Access Compliance Report

Public Rights-of-Way

(Curb Ramps)

Intersection ID: 5897	Main Street: FOREST_POND_DR	Cross Street: PINK_DOGWOOD_LN	Location: S
ADA ID: 284277A46A56	Ramp Type: BlendTrans1	Initial Pass/Fail: Fail	Overall Compliance: No
Severity Score: 10			
Codes/Mitigation Info/Possible Solution		Field Measurements/Component Compliance

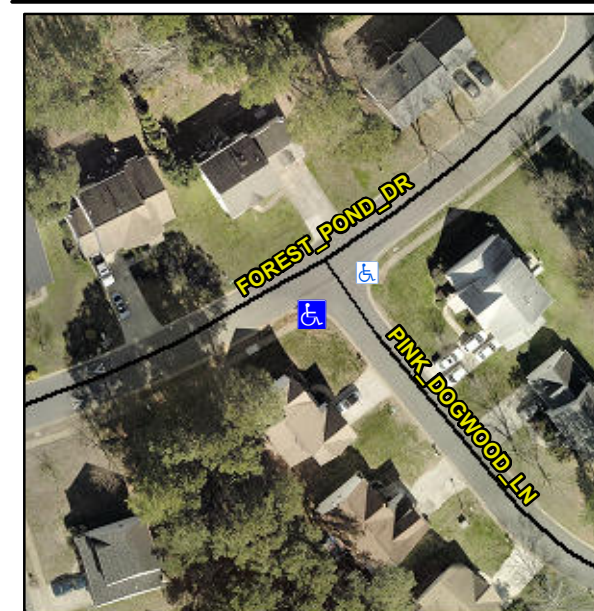
Not Found, R304.5.1, R304.5.3

Compliance	Description	Data	Compliance	Description	Data
N/A	Ramp Length (in)	98.0	Yes	BlendTrans Slope (%)	4.9
No	Ramp Width (in)	46.0	No	BlendTrans XSlope (%)	4.2
N/A	Flare Type LT	N/A	N/A	Flare Type RT	N/A
N/A	Flare Slope LT (%)	N/A	N/A	Flare Slope RT (%)	N/A
N/A	Flare Traversable LT?	N/A	N/A	Flare Traversable RT?	N/A
N/A	Landing Length (in)	N/A	N/A	DWS Provided?	N/A
N/A	Landing Width (in)	N/A	N/A	DWS Contrast?	N/A
N/A	Landing Slope (%)	N/A	N/A	DWS Length (in)	N/A
N/A	Landing X Slope (%)	N/A	N/A	DWS Full Width?	N/A
N/A	Landing Curb? (Y/N)	N/A	N/A	DWS Offset (in)	N/A
N/A	Shared Landing?	N/A			
N/A	Gutter Ponding?	N/A	N/A	Gutter Slope (%)	N/A
N/A	Gutter Lip Ht (in)	N/A	N/A	Gutter X Slope (%)	N/A
N/A	Painted X Walk1?	No	N/A	Painted X Walk2?	N/A
	X Walk 1 Direction	To NE		X Walk 2 Direction	N/A
	X Walk 1 Width (in)	N/A		X Walk 2 Width (in)	N/A
	X Walk 1 Slope (%)	3.6		X Walk 2 Slope (%)	N/A
	X Walk 1 X Slope (%)	2.9		X Walk 2 X Slope (%)	N/A

N/A	Ramp inside XWalk1?	N/A	N/A	Ramp inside XWalk2?	N/A
	Road Slope (%)	2.9		Clear Space?	N/A
	Road X Slope (%)	3.6	N/A	Clear Space to XWalk (in)	N/A
N/A	Any Obstructions?	N/A	N/A	Storm Grate/Utility Hazard?	N/A
	Obstruction Type			Storm Grate/Utility Type	
		N/A			N/A
			Yes	Surface Condition? (G/P)	Good
			No	Curb Slope (%)	9.6

Remove & Replace Curb Ramp With Two New Directional Ramps or Equivalent.
